<b>Model</b>	ADF for F11 (Ricoh DF52)	<b>Volt/Hz</b>	<b>Date of Modification</b>	<b>Serial Number</b>
<b>Modified Article</b>	Left Hinge			
<b>Reason for Modification</b>	To ensure the DF up and down operation

<b>Model</b>	ARDF for F11 (Ricoh DF52)	<b>Volt/Hz</b>	<b>Date of Modification</b>	<b>Serial Number</b>
<b>Modified Article</b>	Front Frame			
<b>Reason for Modification</b>	Parts standardization with ARDF for N230

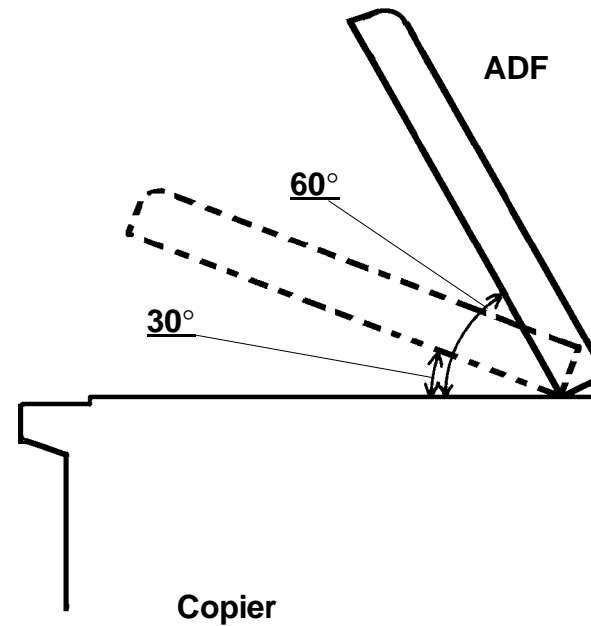
When the operator opens the DF, it may open too fast after it reaches approximately 30 degrees as shown in the illustration.

To prevent this, tension of the springs in the DF left hinge has been changed. The new left hinge will not let the DF open too fast even after it reaches approximately 60 degrees.

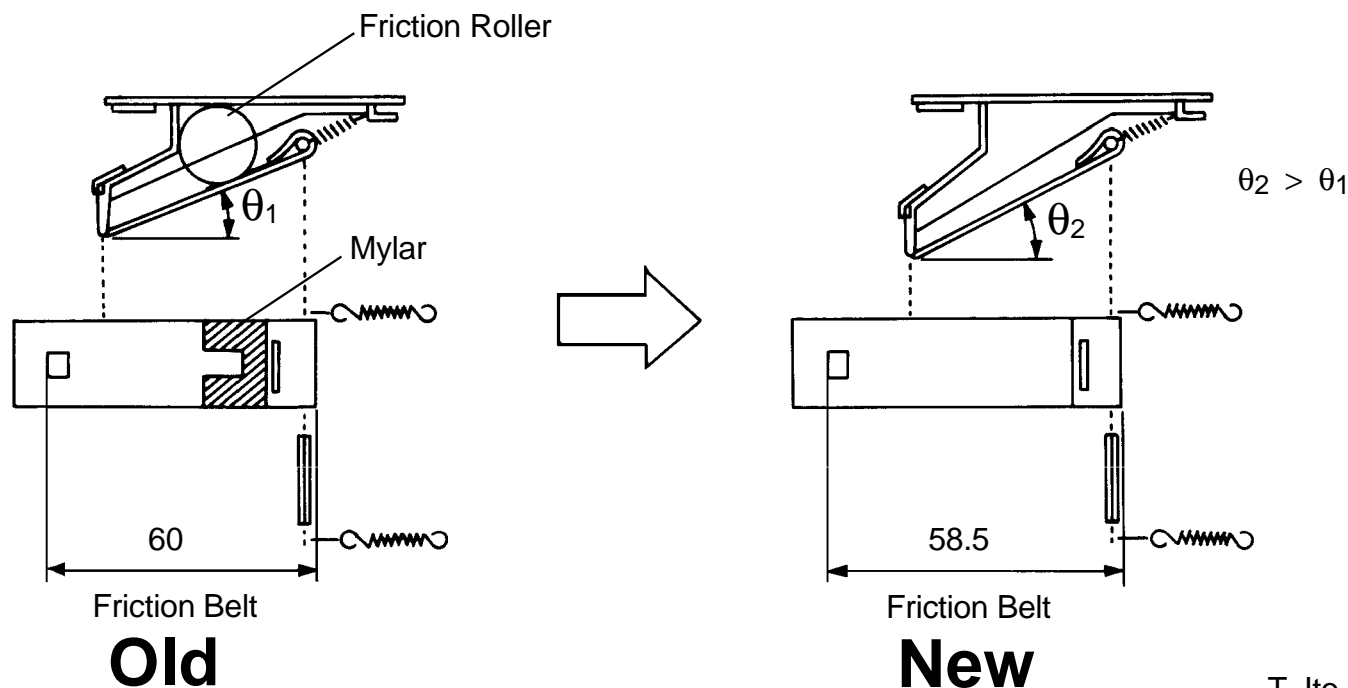
To ensure the original separation, we found that it is more effective to increase the angle ( $\theta$ ) as shown. These are the modifications on production machines to change the angle from  $\theta_1$  to  $\theta_2$  :

1. The friction roller has been removed.
2. The mylar on the friction belt has been removed.
3. The dimension of the friction belt has been changed.

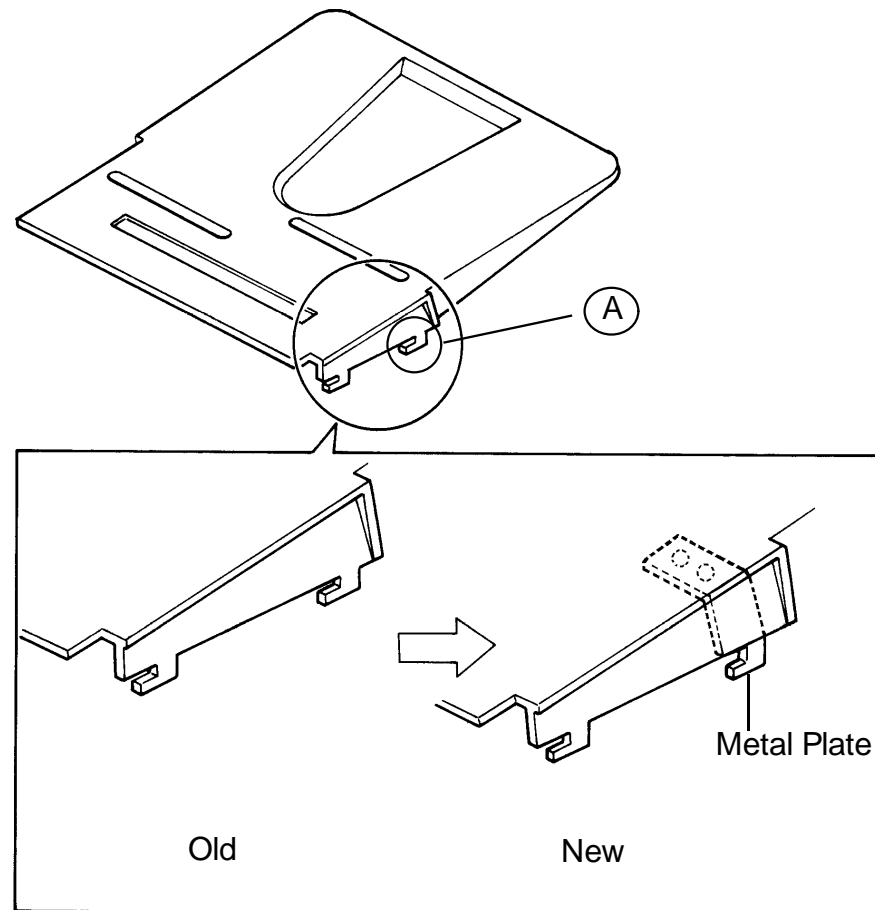
The operators often open and close the DF by holding the original table. After about 1000 ~ 3000 times, (A) of the original table will break. To prevent this problem, the material of (A) has been changed to metal.

<b>Model</b>	ARDF for F11 (Ricoh DF52)	<b>Volt/Hz</b>	<b>Date of Modification</b>	<b>Serial Number</b>
<b>Modified Article</b>	Pull-out Bracket			
<b>Reason for Modification</b>	To prevent original misfeed

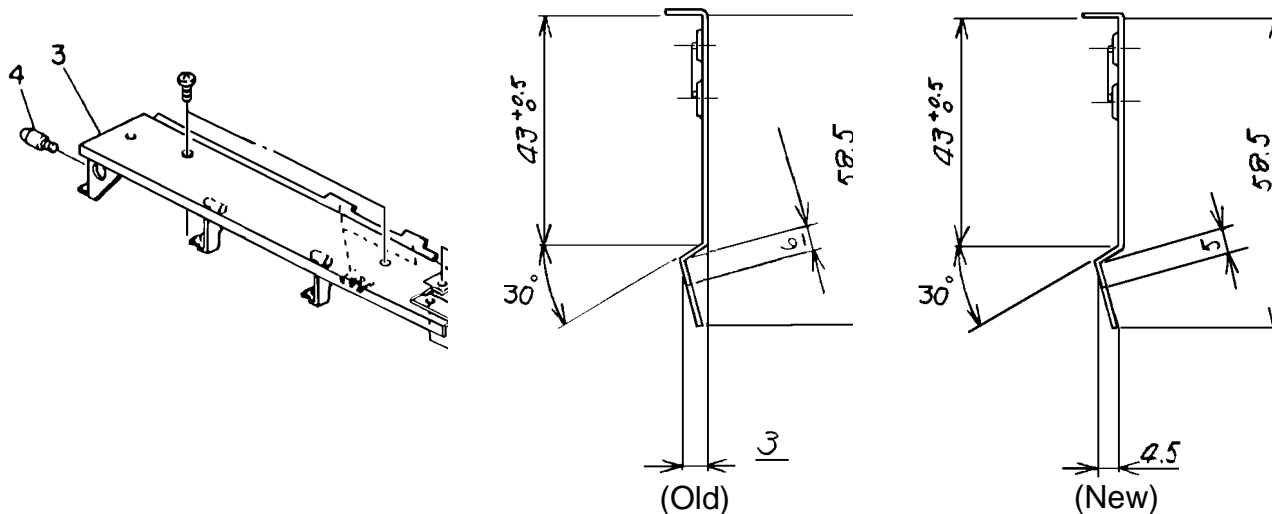
The DF registration sensor is activated by paper dust on the sensor pad, affecting its color. This is because, when the original roller starts rotating, the DF upper plate is warped slightly downward. The clearance between the DF registration sensor and the sensor pad is reduced. To prevent this the pull-out bracket has been modified to improve the clearance.

<b>Model</b>	ARDF for F11 (Ricoh DF52)	<b>Volt/Hz</b>	<b>Date of Modification</b>	<b>Serial Number</b>
<b>Modified Article</b>	Inverter Roller			
<b>Reason for Modification</b>	Parts standardization

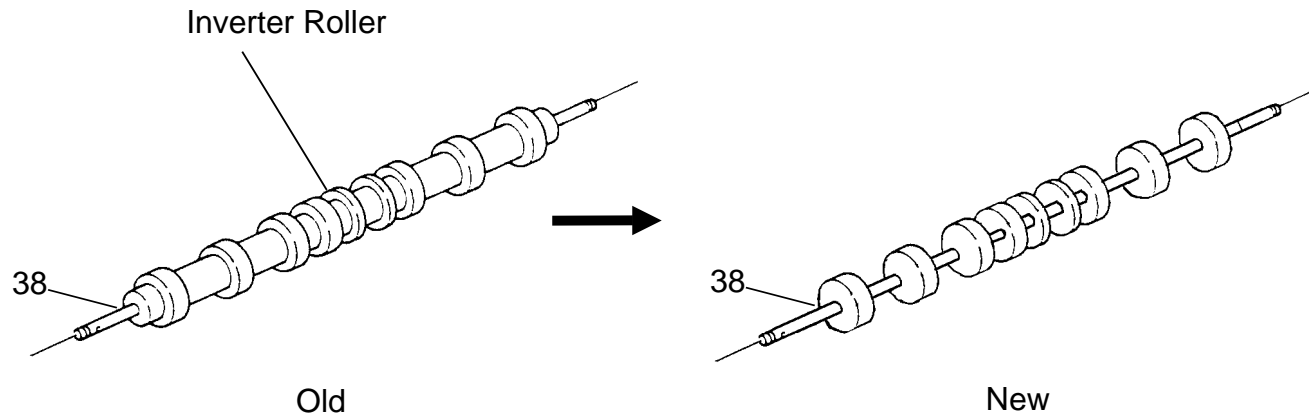
To standardize the parts with other models, the following parts have been changed.
